# Agenda Supplement

August 9, 2023  
HDC Meeting

## Information Submitted by the Public

## 1 - Wilmore Neighborhood

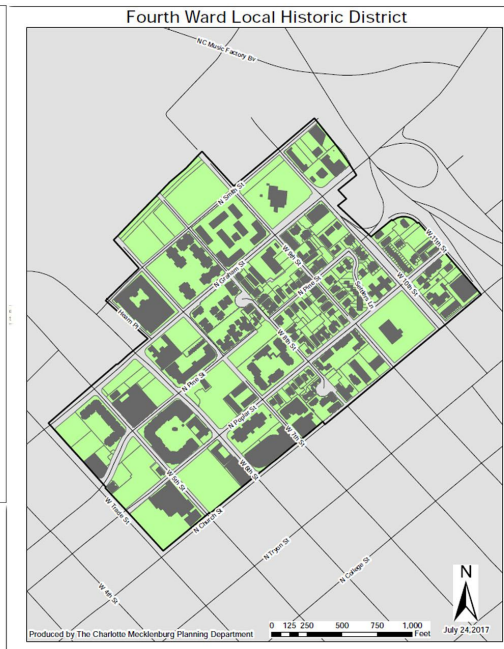
Historic Wilmore is not at all akin to Historic Fourth Ward, where there are several multi-story buildings. There is not a single building in Historic Wilmore that is more than three (3) stories.

## 2 - Context on W. Kingston Ave.

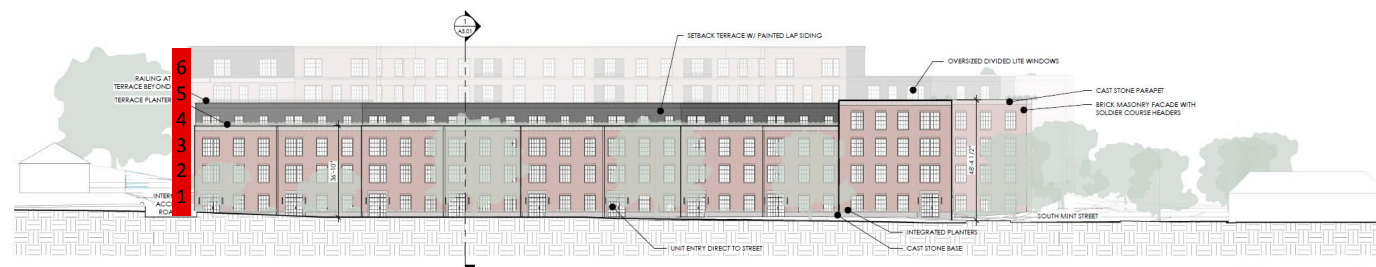
1929 Sanborn Insurance Map, Volume One, Page 46.

Before expansion into a paved parking lot, the Wilmore School lot on West Kingston Ave. was historically seven (7) separate parcels.

The massing and spacing of the proposed development needs to be broken down to fit the neighborhood context of the 1.5- and 2-story single-family homes on separate parcels (seven (7) to be specific).

## 3.2 - Height

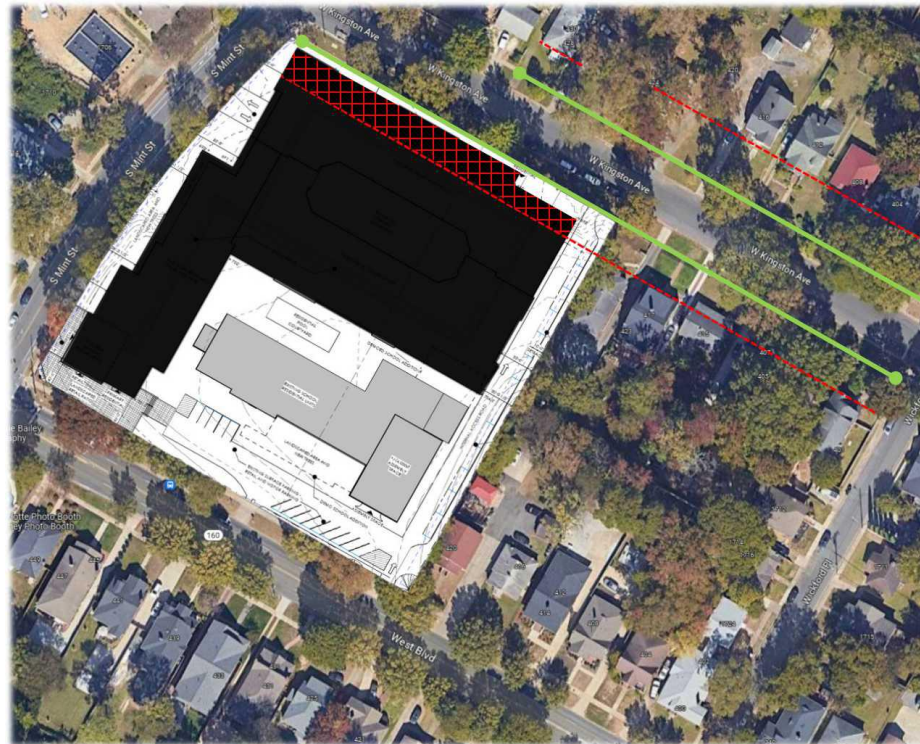
Proposed tallest tower will be significantly visible from different pedestrian viewpoints.

## 4.2 - Setback

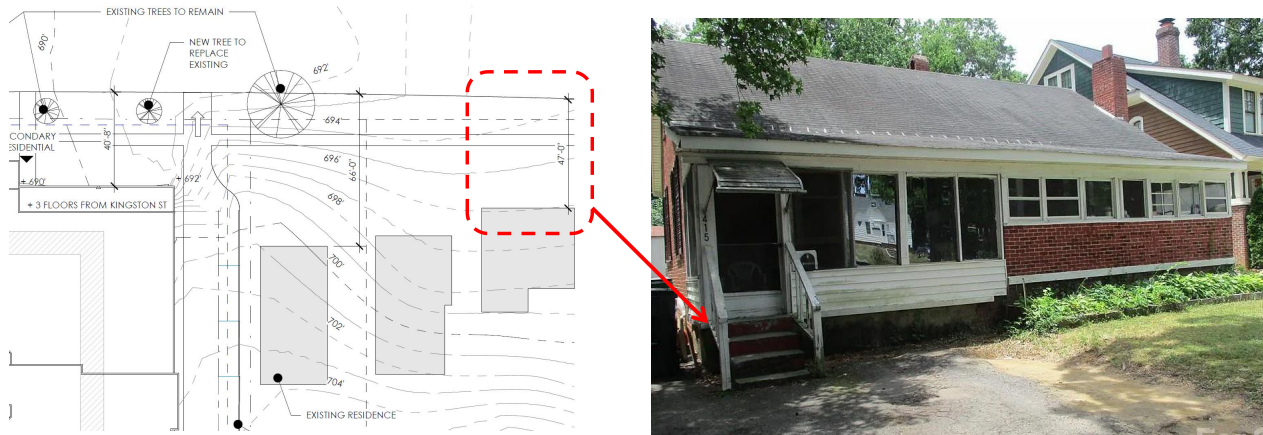
The applicant's referenced setback of 47'-0" for 415 West Kingston Ave. is not accurate, because it is not measured from the thermal wall; rather, the measurement wrongly includes the screened-in front porch. "Setback is the distance between the front thermal wall of the building and the property line or right-of-way boundary at the front of the lot." (Section 6.5 of the CHDDS).
